Town of Hilton Head Island

Design Review Board Meeting

Tuesday, September 10, 2024, 2:30 PM

**1014 William Hilton
Parkway
PLAN SET**

SCALE: 1/4" = 1' - 0"

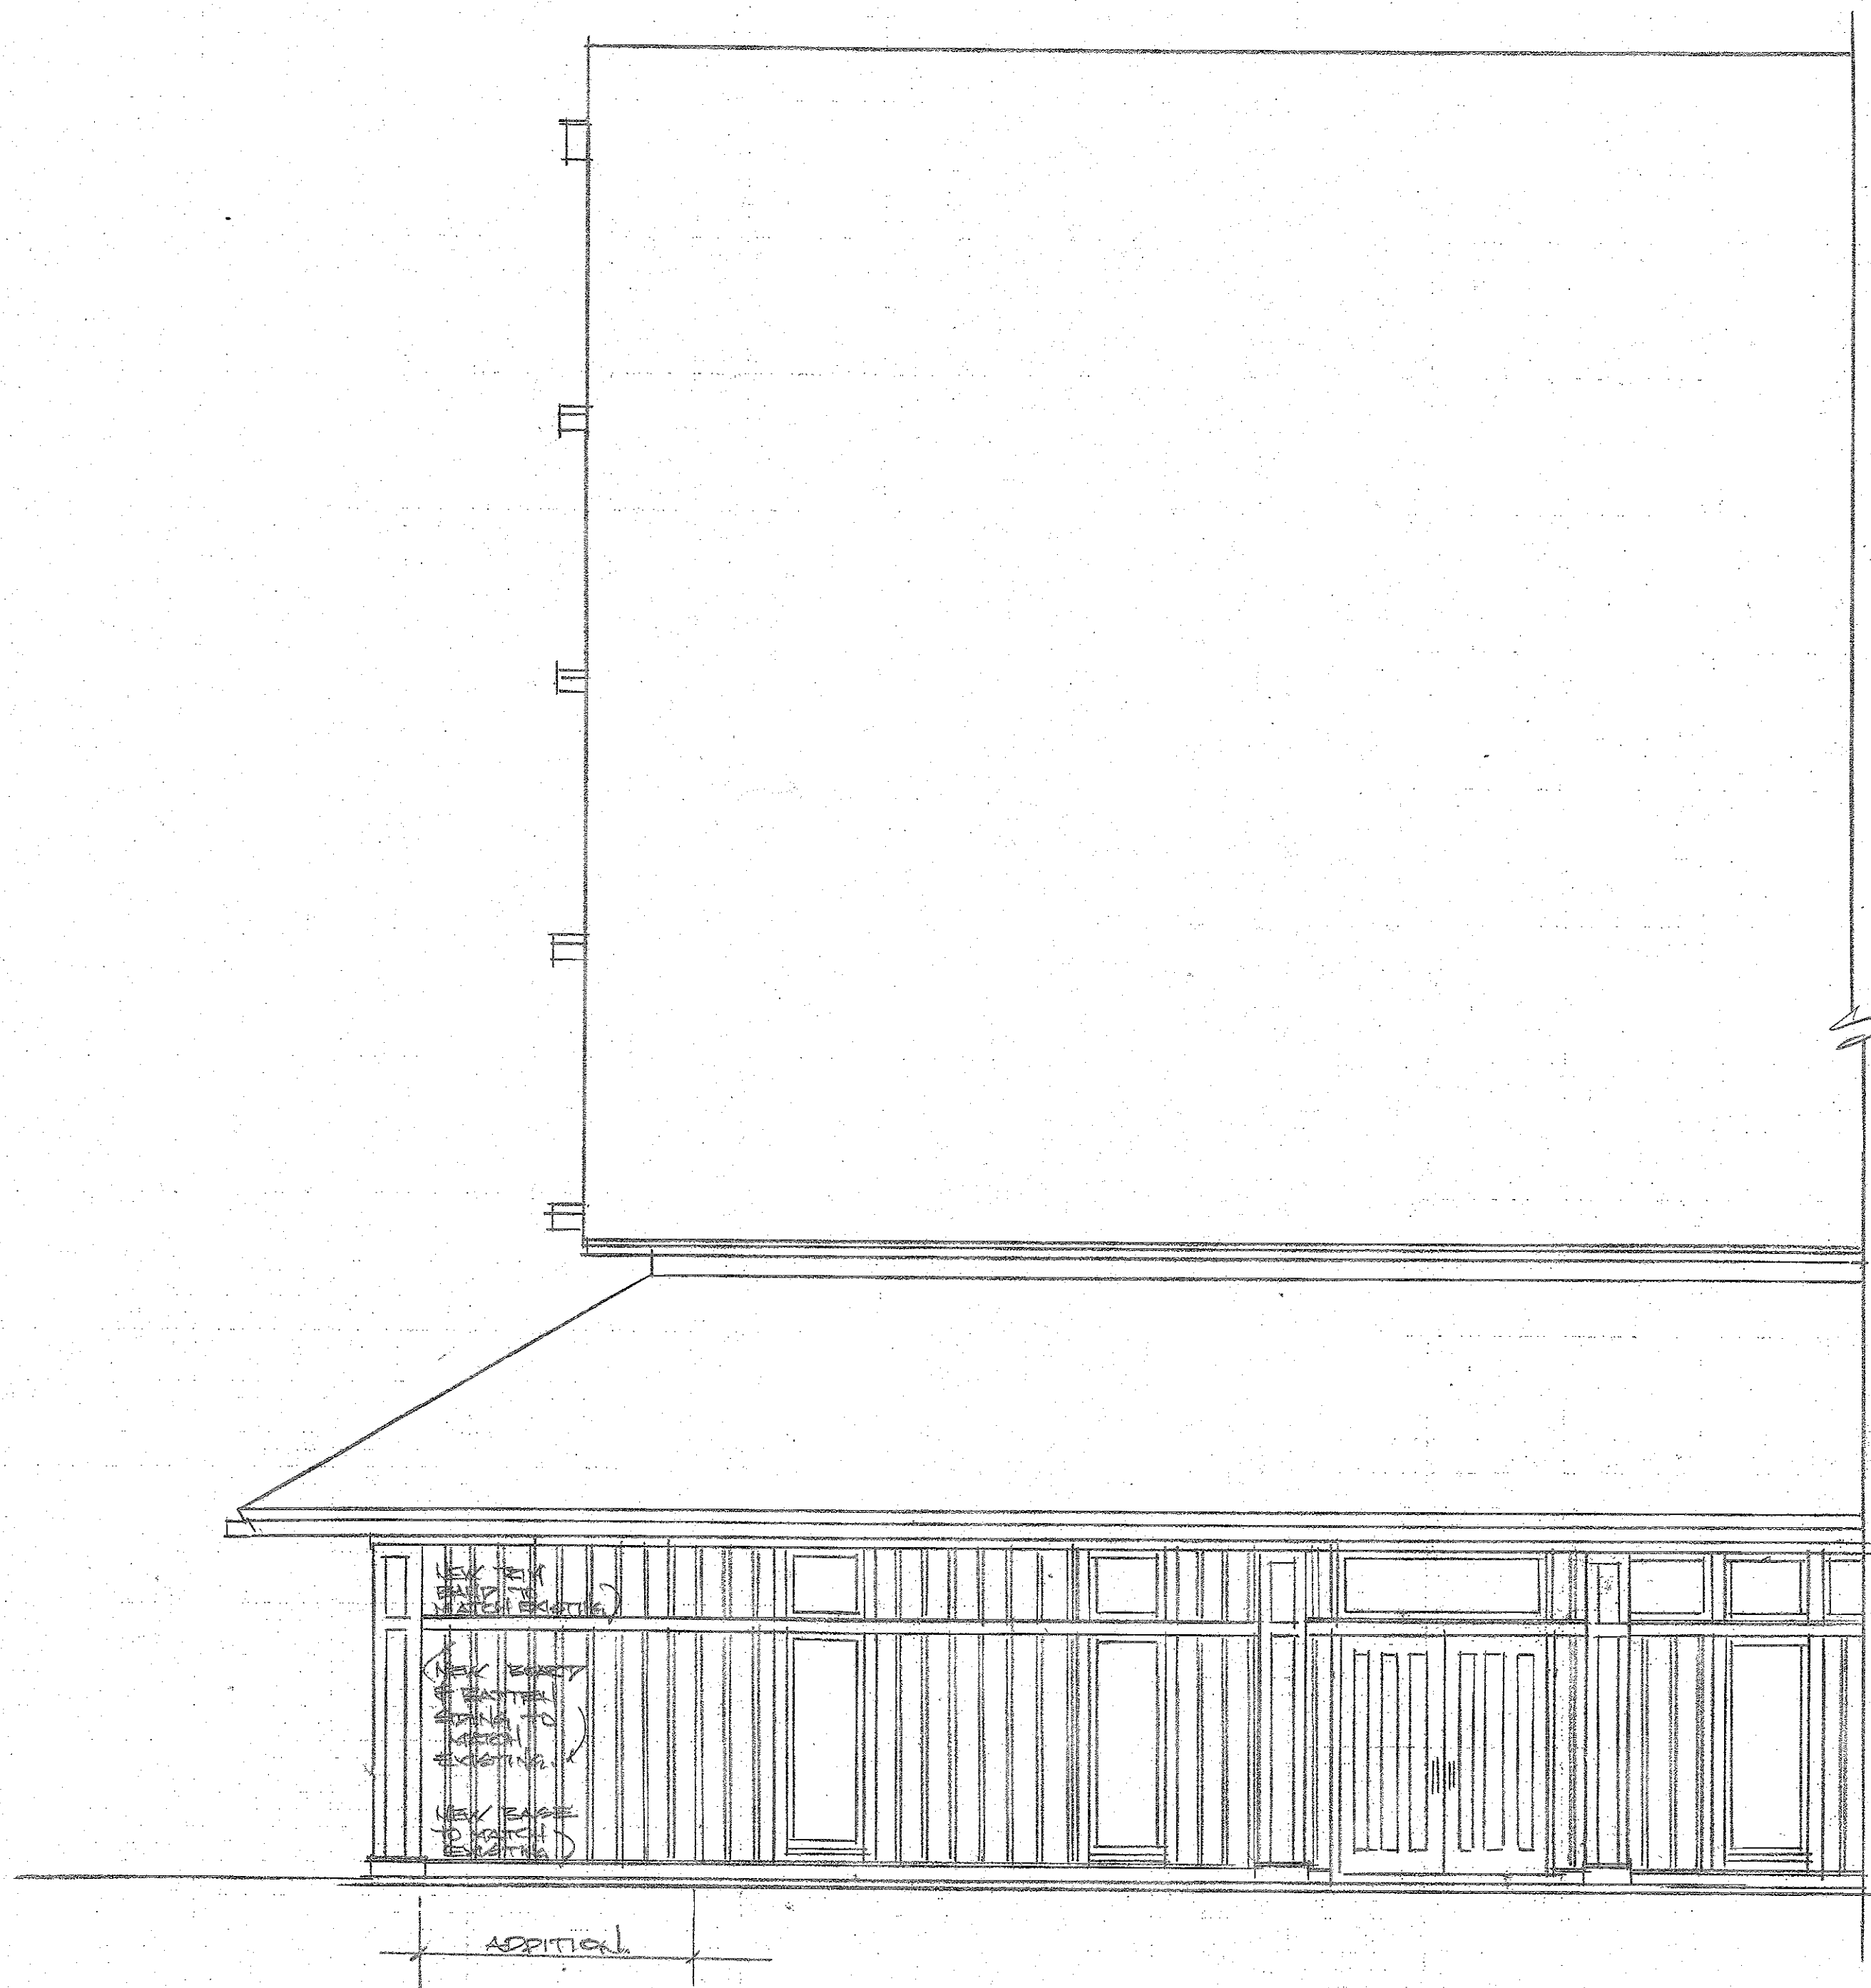
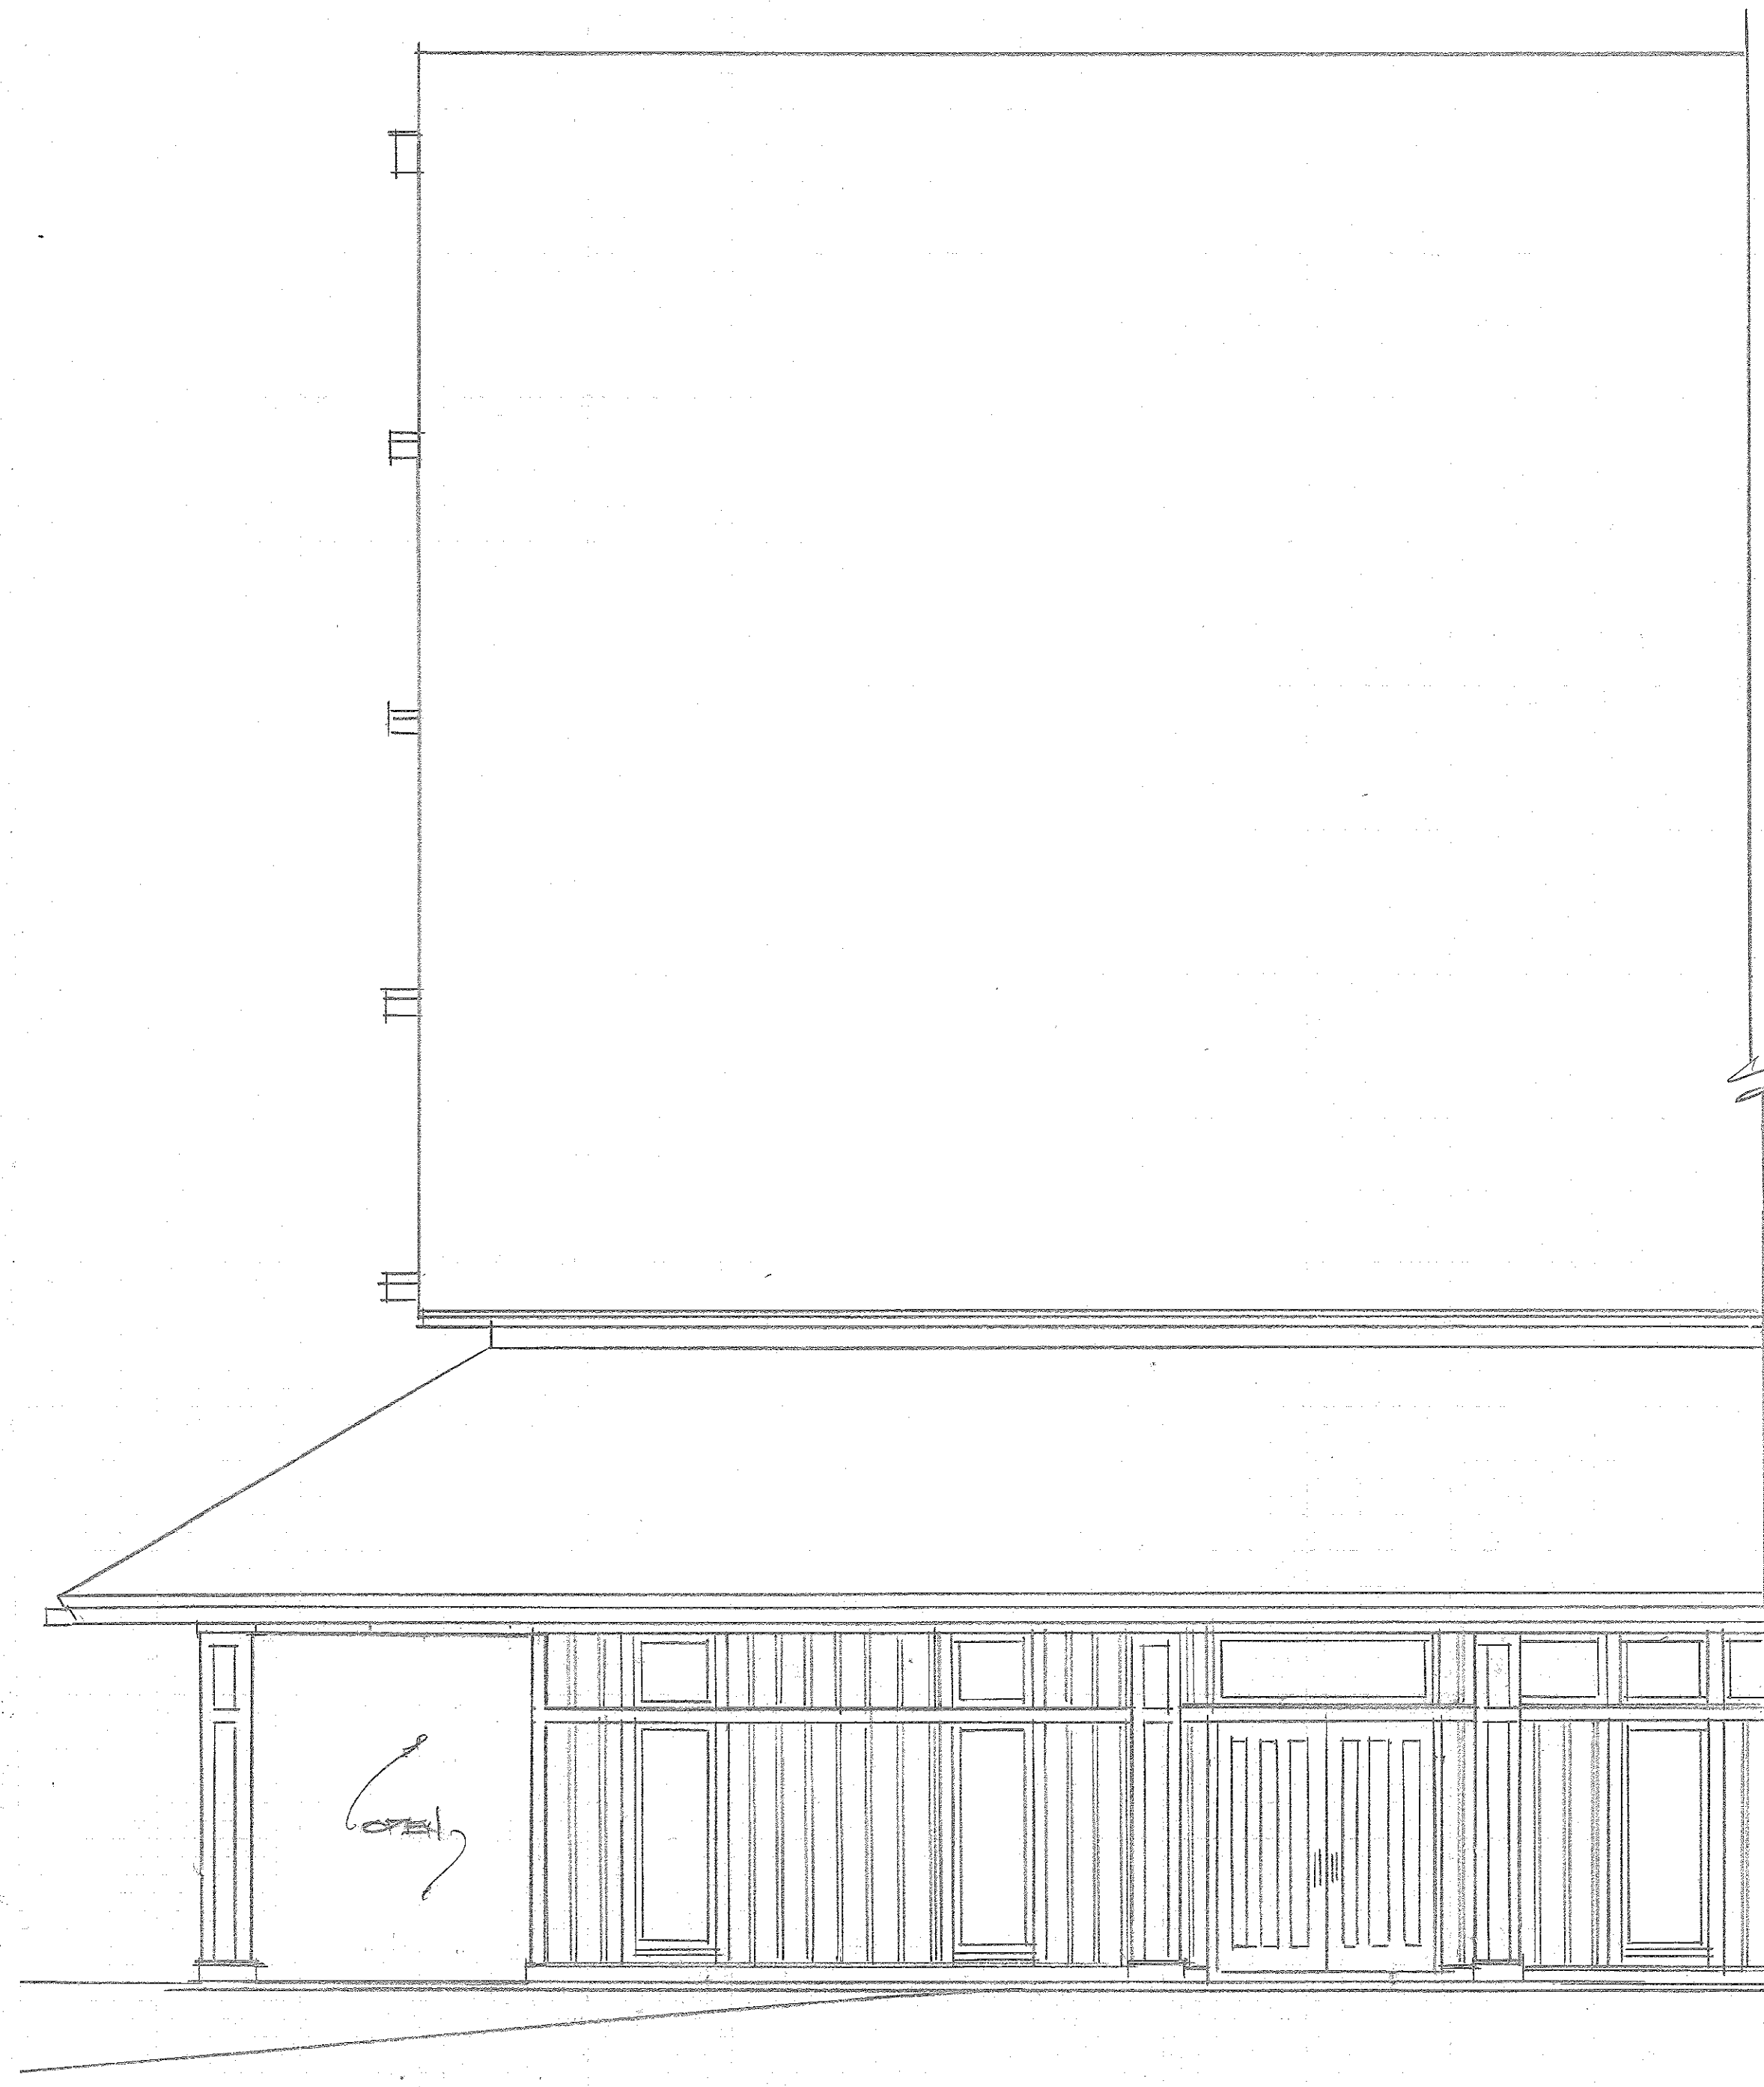
DRB REQUIREMENTS	Complies Yes	No	Not Applicable	Comments or Conditions
Demolition Plan if needed	☒	☐	☐	
Existing Conditions match As-Built	☐	☒	☐	The proposal is to construct bathrooms with A.D.A. handicap facilities for the church sanctuary.
Dimensioned Details and of Sections	☐	☐	☒	Provide dimensions on plans, elevations and sections for Final Review.
Detail Illustrating Connection to Existing Structure	☐	☐	☒	The proposed mural will be painted on an existing brick wall.
New Building Details Match Existing Building Details	☐	☐	☒

DESIGN GUIDE/LMO CRITERIA	Complies Yes	No	Not Applicable	Comments or Conditions
Structure is designed to be appropriate to the neighborhood	☒	☐	☐	
Promotes pedestrian scale and circulation	☒	☐	☐	
Design is unobtrusive and set into the natural environment	☒	☐	☐	
Utilizes natural materials and colors	☒	☐	☐	Provide a 11 x 17 Materials Board for final review.

Avoids distinctive vernacular styles	☒	☐	☐	
Design is appropriate for its use	☒	☐	☐	
All facades shall have equal design characteristics	☒	☐	☐	
Avoids monotonous planes or unrelieved repetition	☒	☐	☐	
Has a strong roof form with enough variety to provide visual interest	☒	☐	☐	
Overhangs are sufficient for the façade height.	☒	☐	☐	
Forms and details are sufficient to reduce the mass of the structure	☒	☐	☐	
Human scale is achieved by the use of proper proportions and architectural elements	☒	☐	☐	
Utilizes a variety of materials, textures and colors	☒	☐	☐	A 11x 17 materials board is required for final review.
Incorporates wood or wood simulating materials	☒	☐	☐	
Windows are in proportion to the facade	☐	☐	☒	
Details are clean, simple and appropriate while avoiding excessive ornamentation	☐	☒	☐	Provide details for final review.
Utilities and equipment are concealed from view	☐	☐	☒	
Decorative lighting is limited and low wattage and adds to the visual character	☐	☒	☐	Any exterior lighting for the bathroom addition shall be submitted for final review.

Accessory elements are designed to coordinate with the primary structure	☐	☒	☐	Provide any exterior elements of the addition to coordinate with the primary structure for final review.

LANDSCAPE DESIGN				
DESIGN GUIDE/LMO CRITERIA	Complies Yes	No	Not Applicable	Comments or Conditions
Treats the Landscape as a major element of the project	☐	☒	☐	Provide a landscape plan indicating the existing and proposed landscaping around the addition.
Provides Landscaping of a scope and size that is in proportion to the scale of the development	☐	☐	☒	
Landscape is designed so that it may be maintained in its natural shape and size	☐	☐	☒	
Preserves a variety of existing native trees and shrubs	☐	☐	☒	
Provides for a harmonious setting for the site's structures, parking areas or other construction	☒	☐	☐	
Location of existing trees and new trees provides street buffers, mitigation for parking lots, and an architectural complement that visually mitigates between parking lots and building(s)	☐	☐	☒	
Shrubs are selected to complement the natural setting, provide visual interest and screen less-desirable	☐	☐	☒

1. Staff recommends approval of the addition with the following conditions to be provided prior to the Final submittal:
 - a. Physical Material and Color Board on a 11”x17” - ask for example if needed
 - b. Provide dimensions on plans, elevations and sections.
 - c. Provide any lighting specs that will be used at the exterior of the addition.

| <ul style="list-style-type: none">d. If you are using exterior lights, provide a lighting plan for final review.e. Provide a landscape plan for any proposed planting around the exterior of the addition.f. Provide a Boundary Survey. <p>2. Any additional information as required by the Board.</p> |
